01 / Record the current installation

R001 - DRAFT SEQUENCE - NOT INSTALLATION APPROVAL

Depth and sealing / review correction

04 / Dry fit the reviewed revision

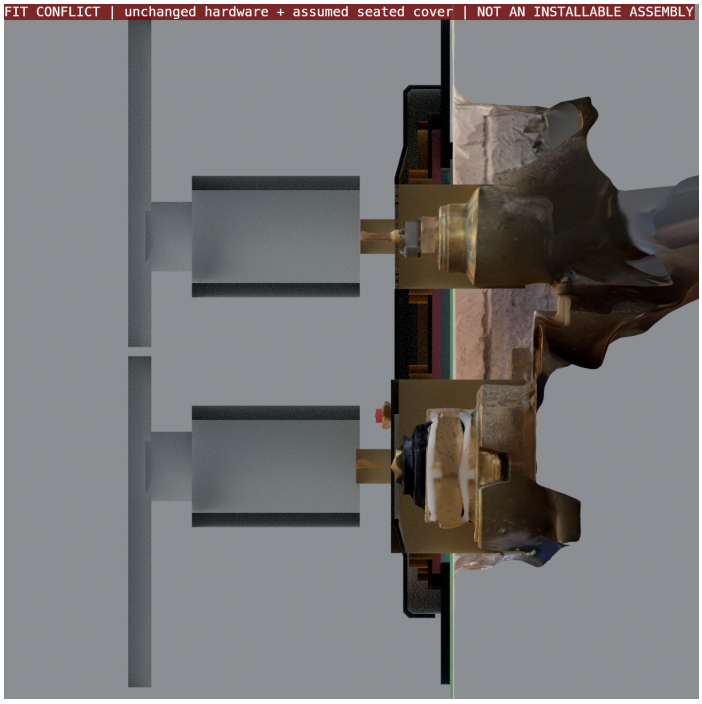
Paper proves no depth clearance. Prototype materials are not approved permanent wet-area materials. Record failures; do not force the fit.

05 / Install only the released material detail

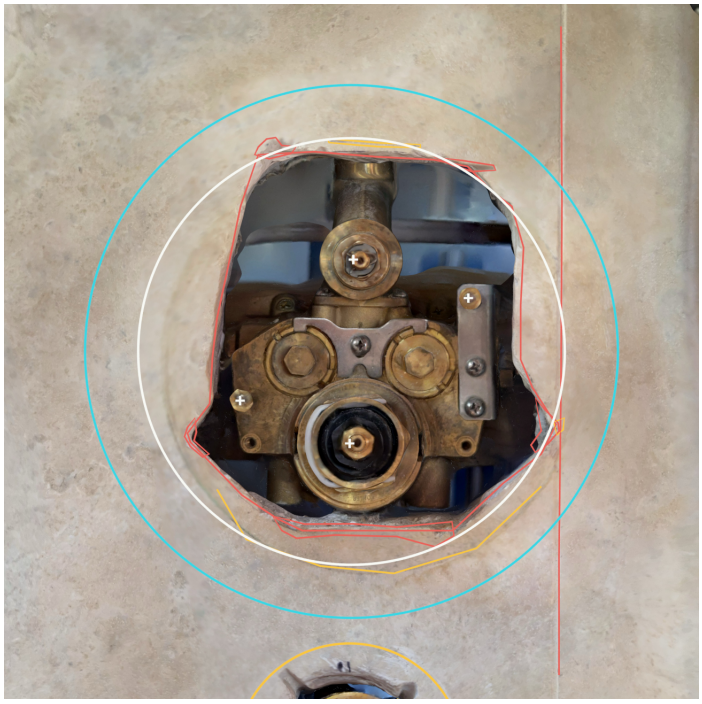
The current seated-cover trial has solid intersections and is rejected. No selected mortar, backing, sealant, finish or cure schedule exists. Do not install from this draft.

The earlier seated-cover image is not a feasible assembly. The unchanged stud envelopes intersect the assumed cover. No captured hardware has been shortened or moved.

Trial / stud	Tip Z, mm	Cover inside Z, mm	Signed gap, mm
Original-wall trial / STUD-SW	26.6	14.5	-12.1
Original-wall trial / STUD-NE	30.7	14.5	-16.2
Trial with added backing plate / STUD-SW	26.6	18.7	-7.9
Trial with added backing plate / STUD-NE	30.7	18.7	-12.0

Negative gap means interference. The assumed nut envelopes clear the cover, but real nut seats, formed metal, rear cavity and compressed foam remain unmeasured. A thicker backing plate also changes hub/adapter engagement and the cover landing.
